CONTRACT FCD 99-05
Phase 3, Santan Collector Channel Project
Southeast Valley Regional Drainage System
PCN 490.01.33

Phase 3, Santan Collector Channel Project
Southeast Valley Regional Drainage System Project
FCD 99-05
PCN 490.01.33
ADDENDUM NO. 2
November 16, 1999

ADDENDUM NO. 1

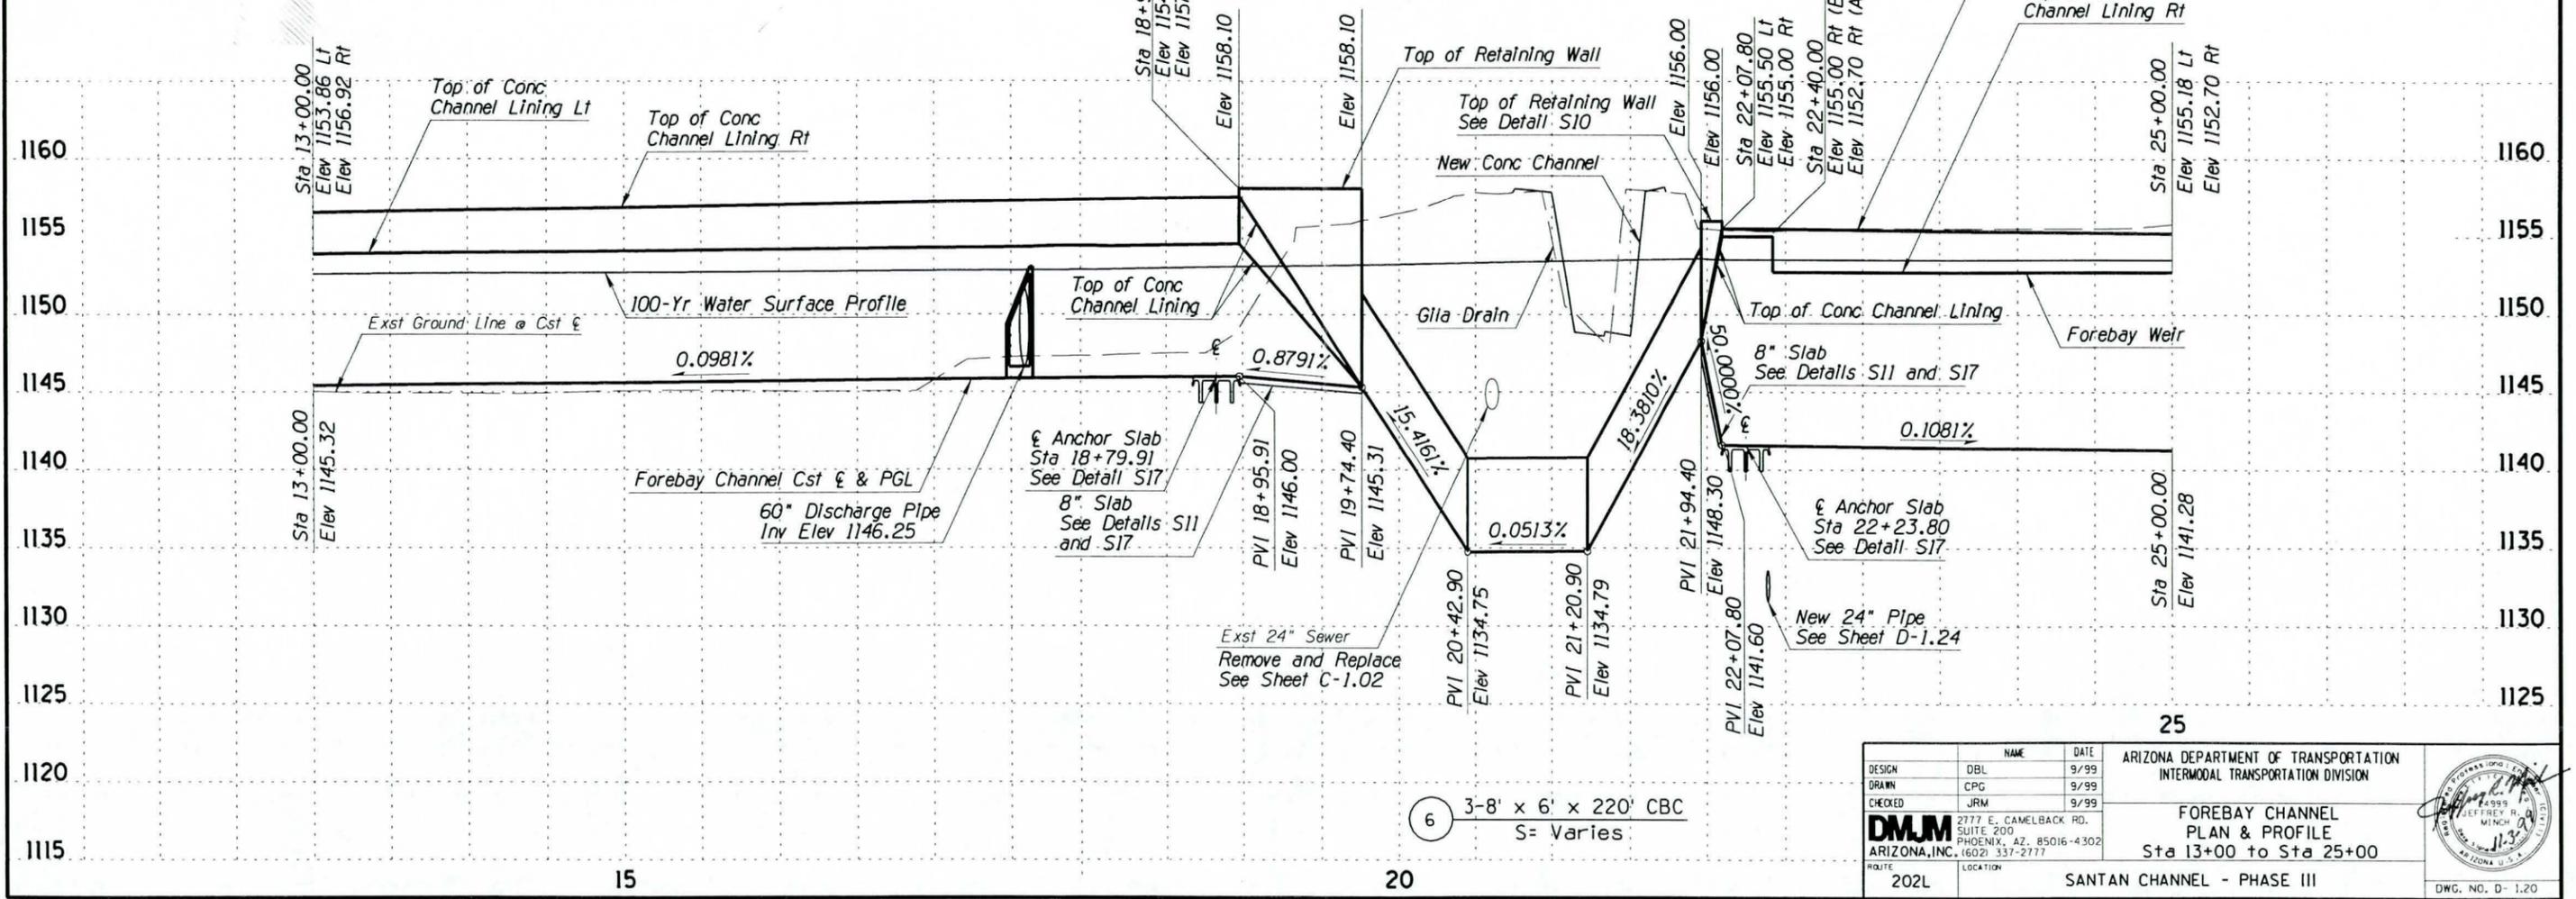
- 34. Sheets D-1.20, D-1.21, D-1.23, D-1.24**
These sheets are revised to show the existing fence along the ADOT Basin complex and to add a note to remove and replace the existing fence per ITEM 350-1 – REMOVE AND REPLACE FENCING. These four revised sheets are attached and made a part of this Addendum No. 1.

SECTION A-A
Scale: 1/2" = 1'-0"

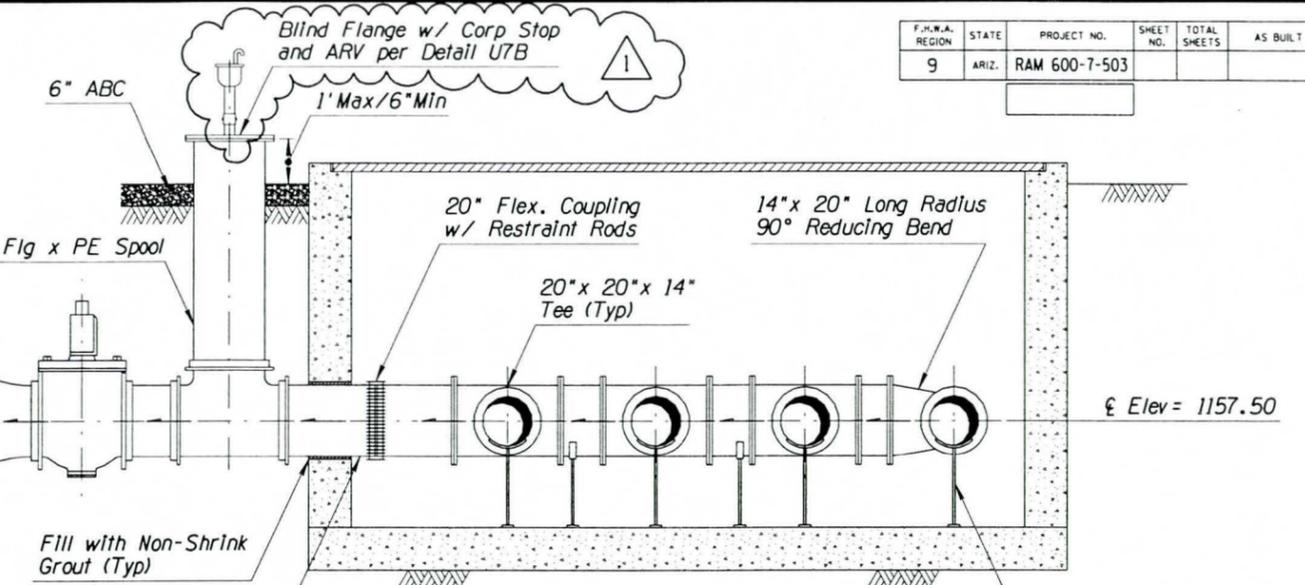
- 39. Sheet U-2.04**
Section A-A is revised to add a 2" air and vacuum relief valve assembly with a 2" bronze corporation stop on top of the blind flange per Detail U7B. The Plan View is revised to add two bollards per Detail D12. This revised sheet is attached and made a part of this Addendum No. 1.

DETAIL U7A
KYRENE LIFT STATION - SCRUBBER DUCT

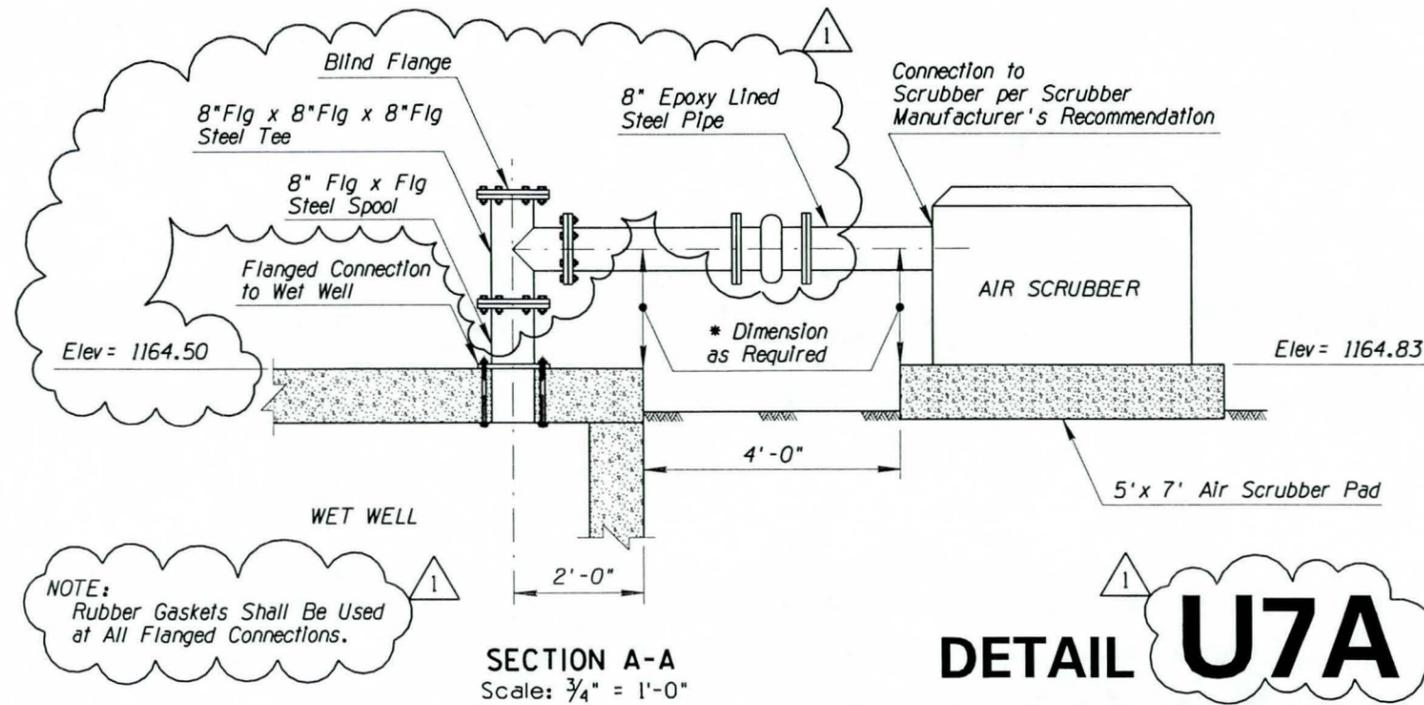
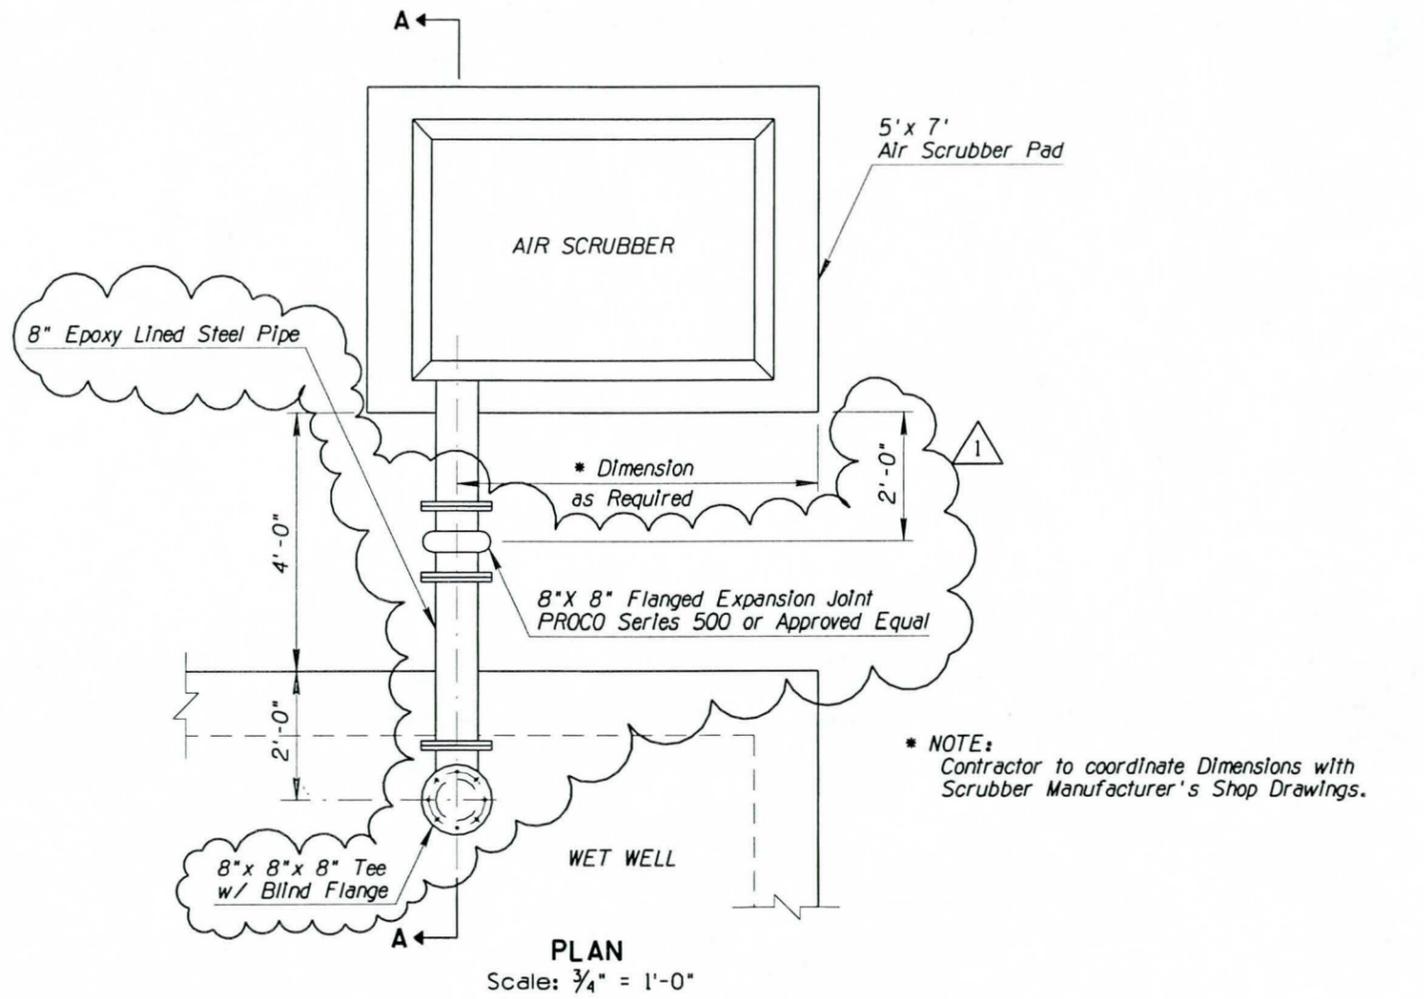
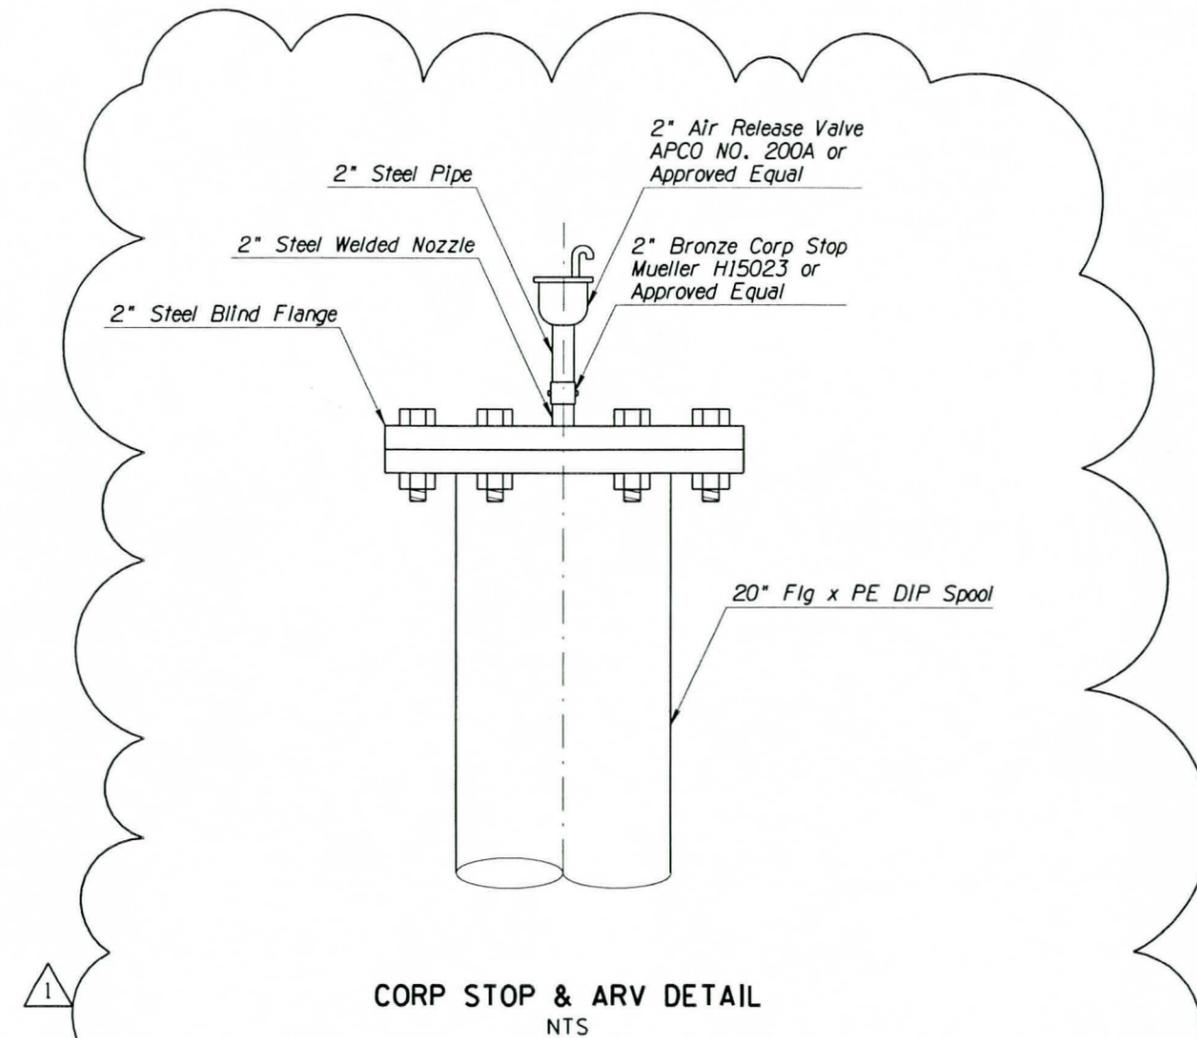
- 40. Sheet U-2.09**
This sheet is revised to add an expansion joint to the 8" steel air pipe and replacing the 90-degree elbow with a tee and a blind flange facing up as shown in Detail U7A. The steel pipe shall be epoxy lined. Detail U7B, per sheet U-2.04 has also been added. This revised sheet is attached and made a part of this Addendum No. 1.

36 INCH WATER
PLAN AND PROFILE
Sta 174+18.95 to Sta 184+67.70

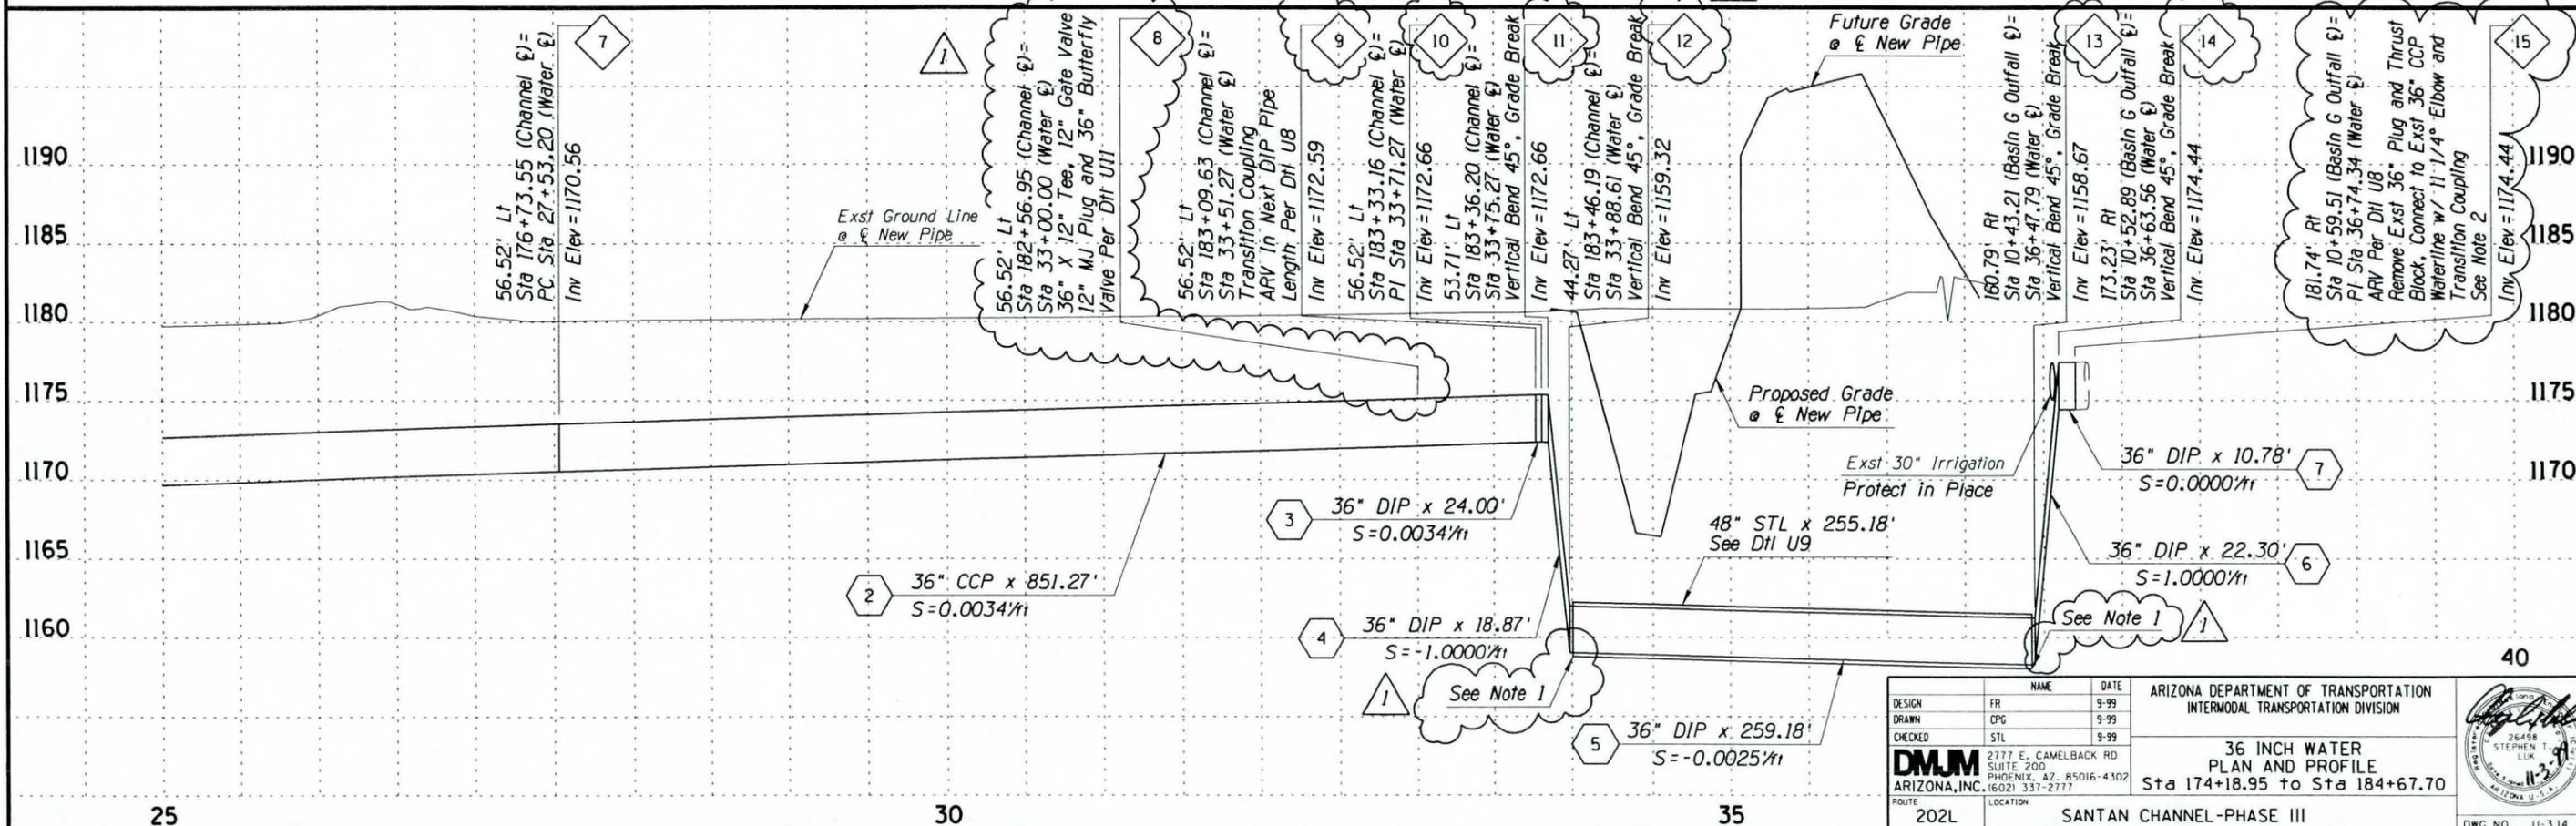
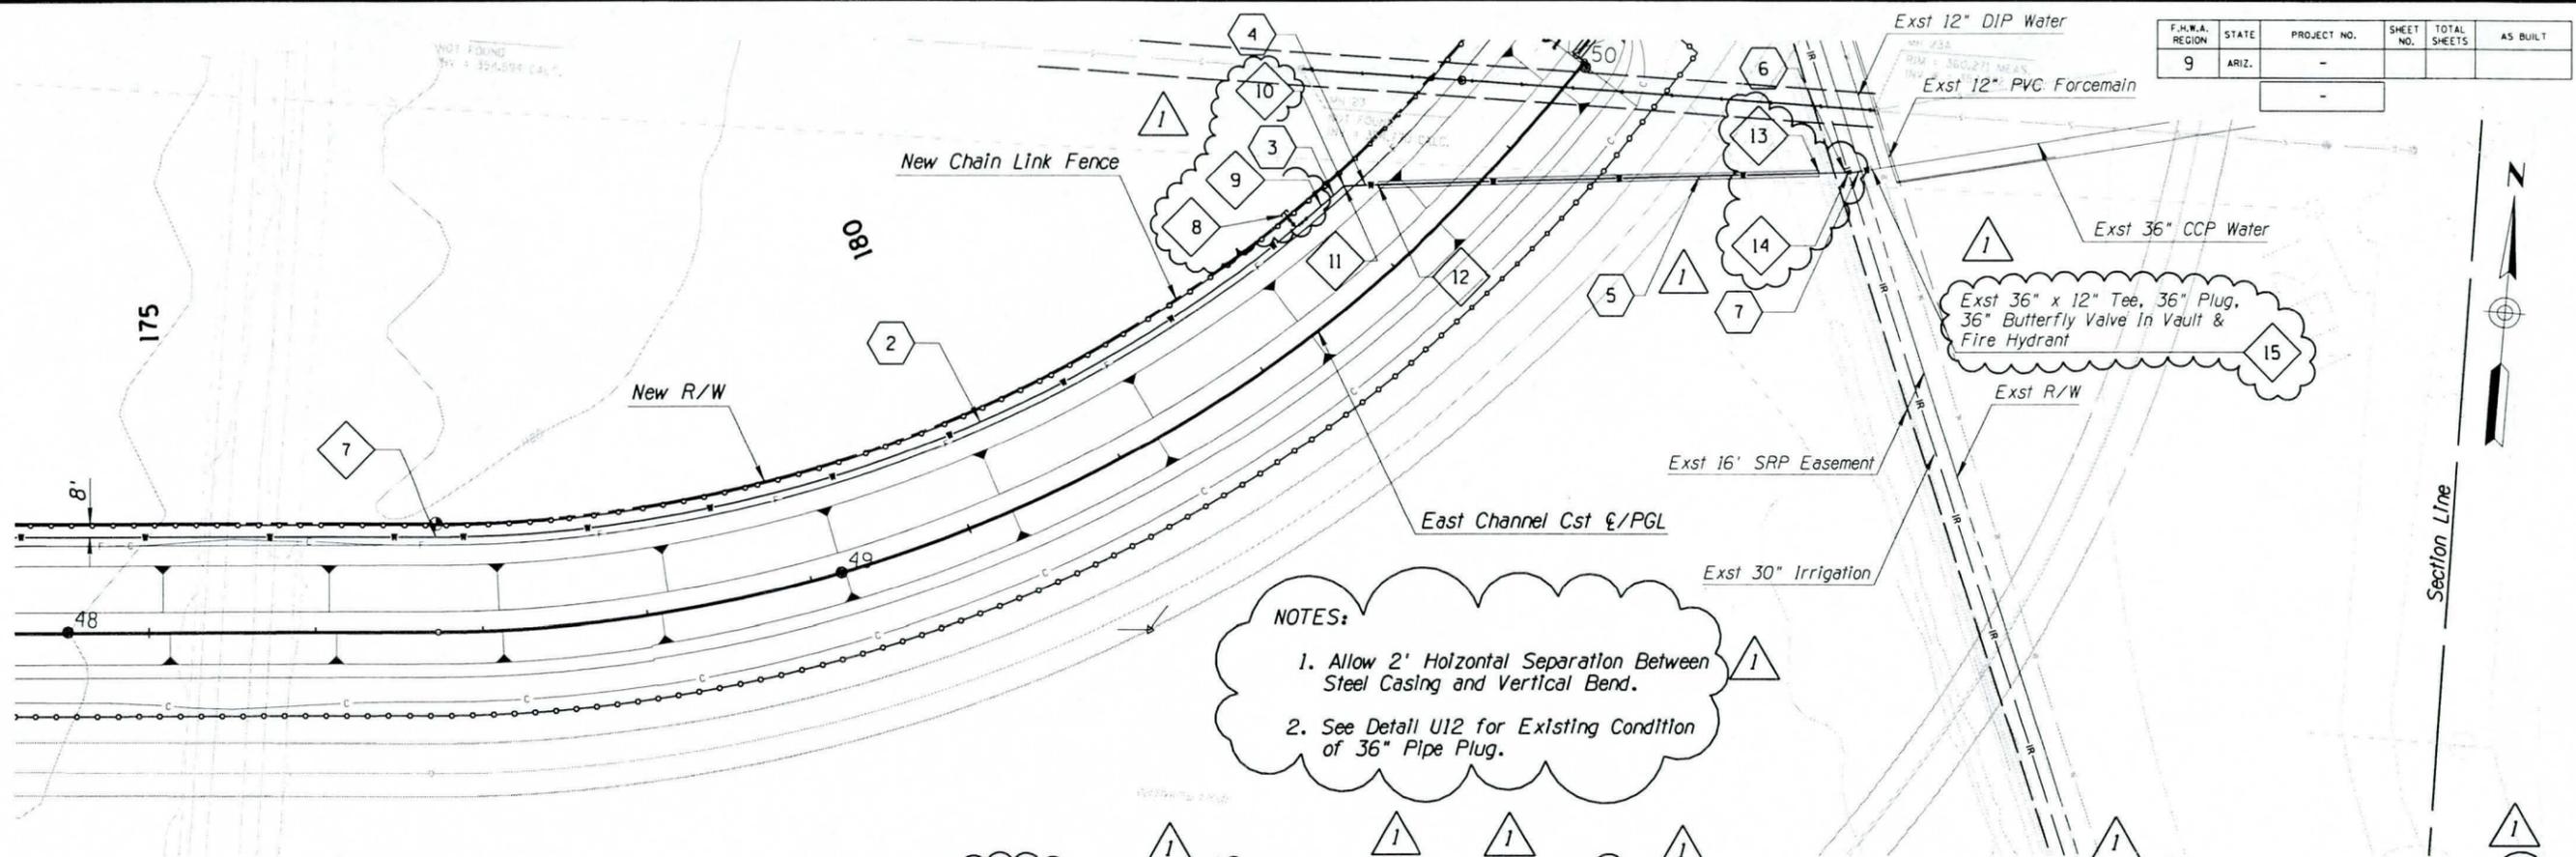
- 41. Sheet U-3.02**
Add a Note 24 to read – "All 24" gate valves shall be resilient wedge type gate valves, without bypass piping."
- 42. Sheet U-3.14**
This sheet is revised to add a 36" service connection at Station 33+00 similar to that shown on sheet U-3.13 at water centerline station 11+34.82. Also, Note 2 has been added. This revised sheet is attached and made a part of this Addendum No. 1.
